SOLICITATION AMENDMENT
MODIFICATION DE L'INVITATION

Title - Sujet Sir Frederick Banting Fit-up	
Solicitation No. - N° de l'invitation EP076-141420/A	Amendment No. - N° modif. 003
Client Reference No. - N° de référence du client 20141420	Date 2014-02-07
GETS Reference No. - N° de référence de SEAG PW-\$\$FG-356-64066	
File No. - N° de dossier fg356.EP076-141420	CCC No./N° CCC - FMS No./N° VME
Solicitation Closes - L'invitation prend fin at - à 02:00 PM on - le 2014-02-20	
Time Zone Fuseau horaire Eastern Standard Time EST	
F.O.B. - F.A.B. Plant-Usine: <input type="checkbox"/> Destination: <input type="checkbox"/> Other-Autre: <input type="checkbox"/>	
Address Enquiries to: - Adresser toutes questions à: Lagacé, Hélène	Buyer Id - Id de l'acheteur fg356
Telephone No. - N° de téléphone (819) 956-0060 ()	FAX No. - N° de FAX (819) 956-8335
Destination - of Goods, Services, and Construction: Destination - des biens, services et construction: Sir Frederick Banting Research Centre 251 Sir Frederick Banting Way Ottawa, Ontario

ADDENDUM NO. 03

4. S203 – PENTHOUSE ROOF PLAN

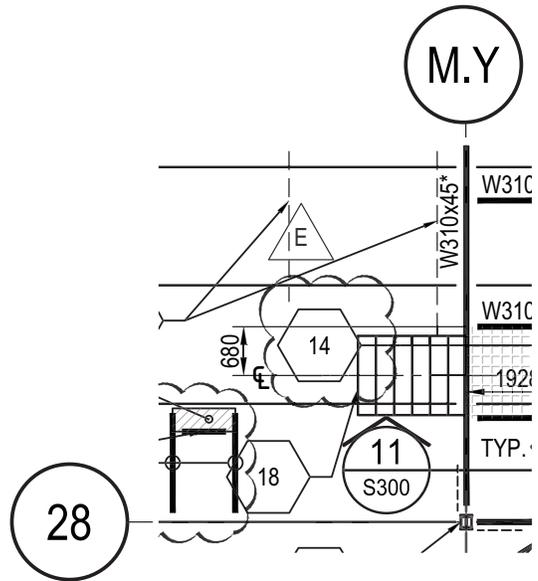
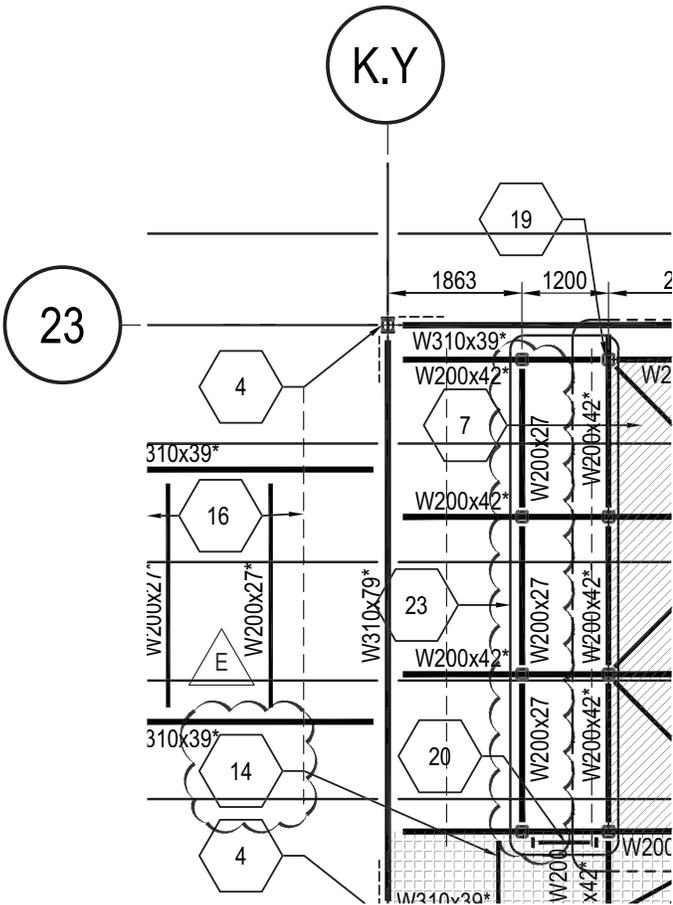
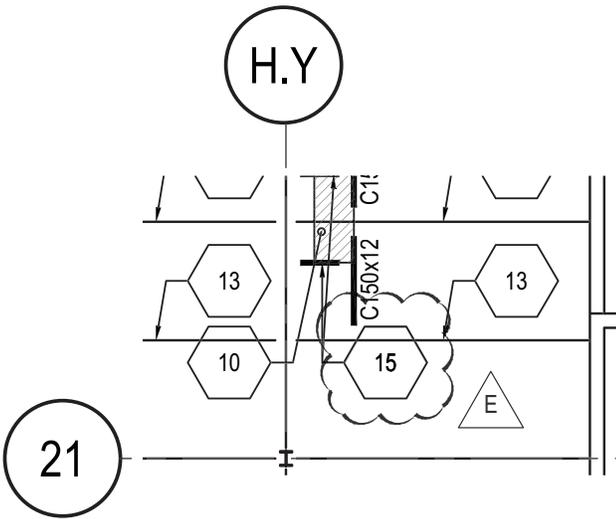
- .1 Change “Keynote 10” to “Keynote 15” pointing to beam to right of grid H.Y as shown on Partial drawing revision FS-S203-04, issued as part of this Addendum.
- .2 Change “Keynote 26” to “Keynote 14” to left of grid M.Y as shown on Partial drawing revision FS-S203-04, issued as part of this Addendum.
- .3 Change “Keynote 26” to “Keynote 14” to left of grid K.Y as shown on Partial drawing revision FS-S203-04, issued as part of this Addendum.
- .4 Clarification: four beams within grids 21-23/M.Y-L.Y are existing beams; three beams near K.Y are W200 x 27 as shown on Partial drawing revision FS-S203-04, issued as part of this Addendum.

14. W200x19*

15. C150x12 TYP. CONNECT BETWEEN EXISTING OWSJ.
